Access Compliance Report

Public Rights-of-Way

Intersection ID: 29243	Main Street: WOODINGTON_LN	Cross Street: CARRINGTON_HILL_DR	Location: W
ADA ID: 701902A05CAC	Ramp Type: PerpDiag	Initial Pass/Fail: Fail	Overall Compliance: No
		Severity Score: 25

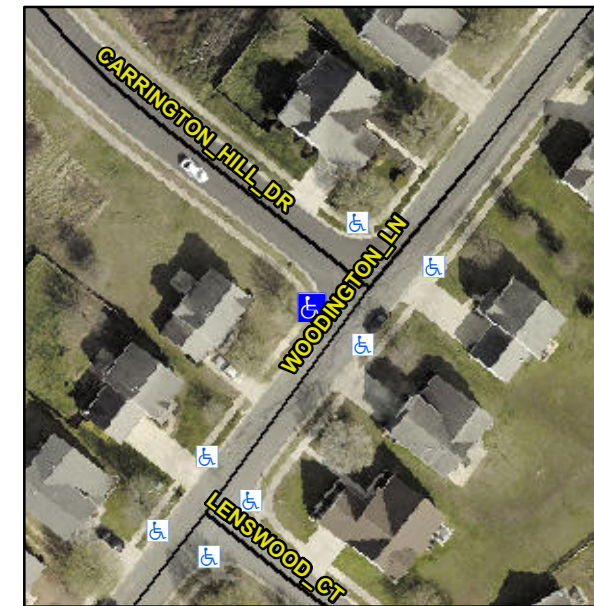
Not Found, R304.5.3

Compliance	Description	Data	Compliance	Description	Data
N/A	Ramp Length (in)	40.0	Yes	Ramp Slope (%)	5.0
Yes	Ramp Width (in)	48.0	No	Ramp XSlope (%)	11.8
N/A	Flare Type LT	N/A	N/A	Flare Type RT	N/A
N/A	Flare Slope LT (%)	N/A	N/A	Flare Slope RT (%)	N/A
N/A	Flare Traversable LT?	N/A	N/A	Flare Traversable RT?	N/A
N/A	Landing Length (in)	N/A	N/A	DWS Provided?	N/A
N/A	Landing Width (in)	N/A	N/A	DWS Contrast?	N/A
N/A	Landing Slope (%)	N/A	N/A	DWS Length (in)	N/A
N/A	Landing X Slope (%)	N/A	N/A	DWS Full Width?	N/A
N/A	Landing Curb? (Y/N)	N/A	N/A	DWS Offset (in)	N/A
N/A	Shared Landing?	N/A			
N/A	Gutter Ponding?	N/A	N/A	Gutter Slope (%)	N/A
N/A	Gutter Lip Ht (in)	N/A	N/A	Gutter X Slope (%)	N/A
N/A	Painted X Walk1?	No	N/A	Painted X Walk2?	No
	X Walk 1 Direction	To SE		X Walk 2 Direction	To NE
N/A	X Walk 1 Width (in)	N/A	N/A	X Walk 2 Width (in)	N/A
	X Walk 1 Slope (%)	3.6		X Walk 2 Slope (%)	4.4
	X Walk 1 X Slope (%)	5.5		X Walk 2 X Slope (%)	6.5

Remove & Replace Curb Ramp With Two New Directional Ramps or Equivalent.
